**Broadland Flood Alleviation Project:
Compartment 37 (Upton Dyke) - Variation of Condition 1 of Planning
Permission BA/2015/0364/FUL to allow removal of piling and realignment of
floodbank close to existing culvert
(chainage 3962 to 3980)
(Planning Ref no. BA2016/0422/COND)**

Report by Planning Officer

Summary: This report provides Members with details of Broadland Environmental Services Ltd (BESLs) application that seeks to vary the existing planning permission flood defence works for a short section of the dyke (18 metres in length) adjacent to an existing culvert (following earlier permission for more extensive works granted earlier this year. It concludes that the proposed change to the approved scheme should safeguard and enhance navigation interests (subject to the imposition of the same planning conditions imposed on consent BA/2015/0364/FUL).

**COMPARTMENT 37
RIVER BURE
ADDITIONAL PILING REMOVAL
DETAILED PLAN 1 OF 1**

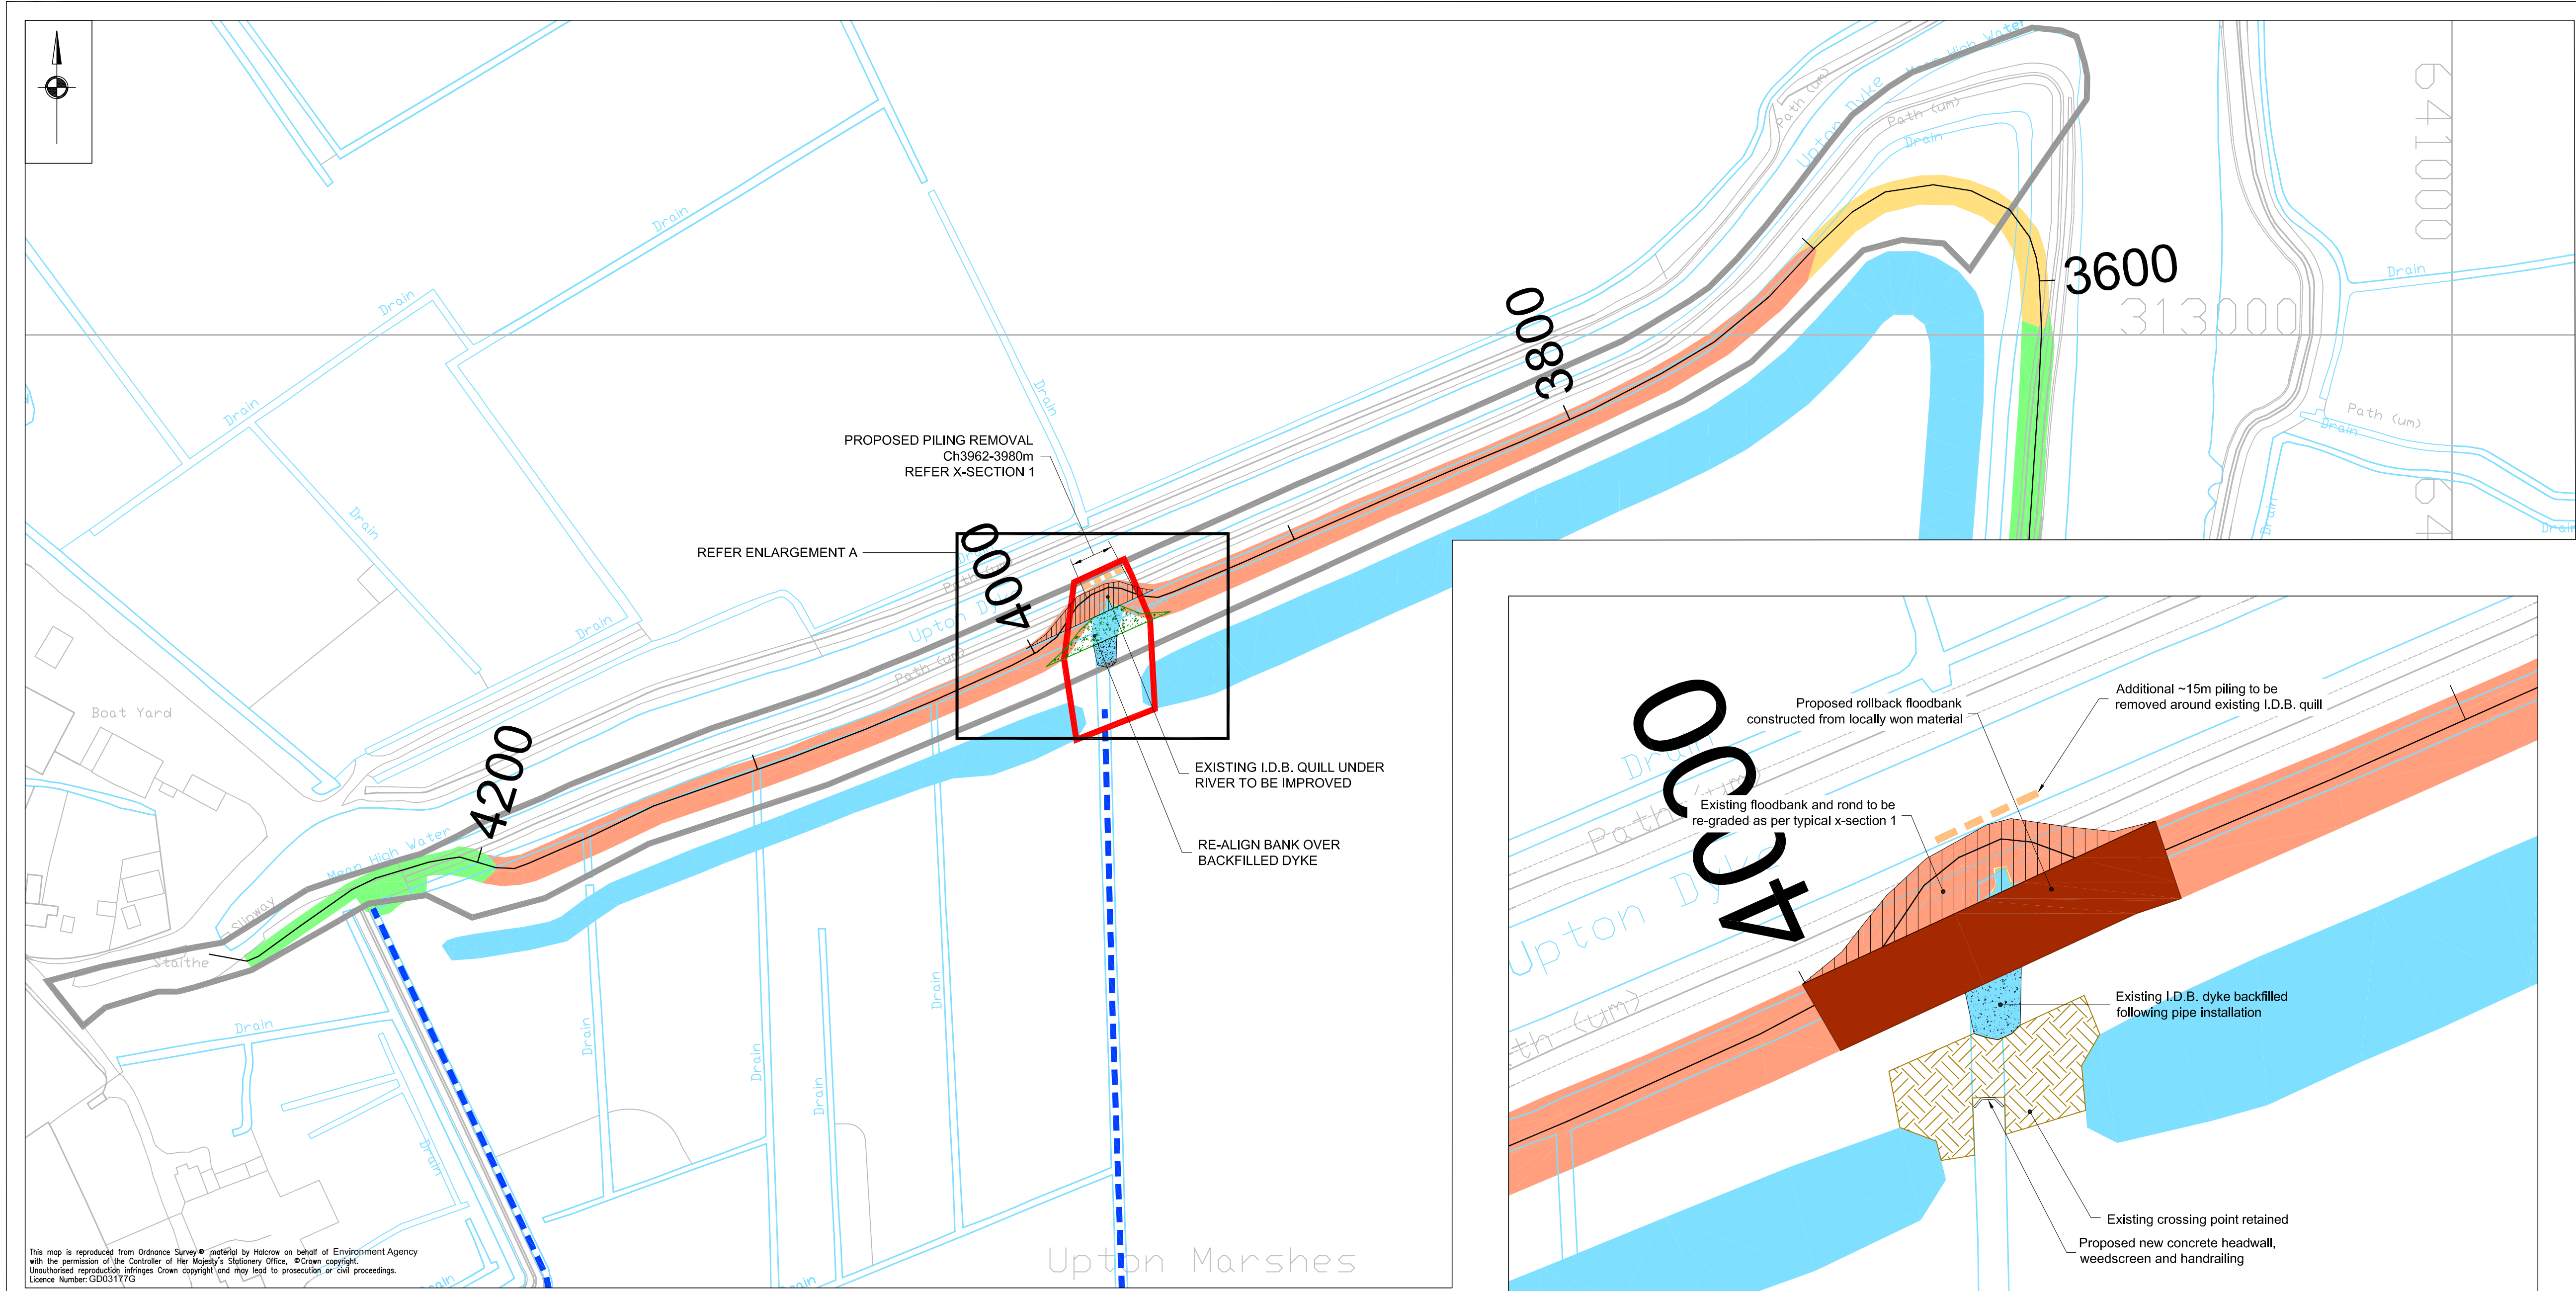
- 2.1 The application effectively seeks consent to permit an additional 18 metres of flood defence works in the form of rollback and re-profiling of the bank to match the scheme approved along the rest of the Upton Dyke bank.

- 2.2 All previous consents for works in the Dyke recognise the potential for erosion and siltation associated with flood defence and pile driving works. In this application BESL have devised works to limit risk, notably in relation to the shallow profile of edge proposed in the 18 metre length of Dyke edge where pile driving / removal is proposed. In addition, the proposed variation will ensure that all previously agreed erosion monitoring and mitigation measures associated with the remaining works in Upton Dyke will apply.

- 2.3 The application, if approved, would remove a pinch-point in the dyke that should benefit navigation, given the current limited width of the dyke at this point. The piling is no longer needed for erosion protection purposes and its removal (subject to safeguards) and associated rollback of the floodbank would deliver flood defences in a more sustainable manner (consistent with other works approved in Upton Dyke).

- 2.4 Therefore the proposed additional 18 metres of works is welcomed and would increase width (and remove a pinch point in the Dyke) and that should represent a modest navigation improvement
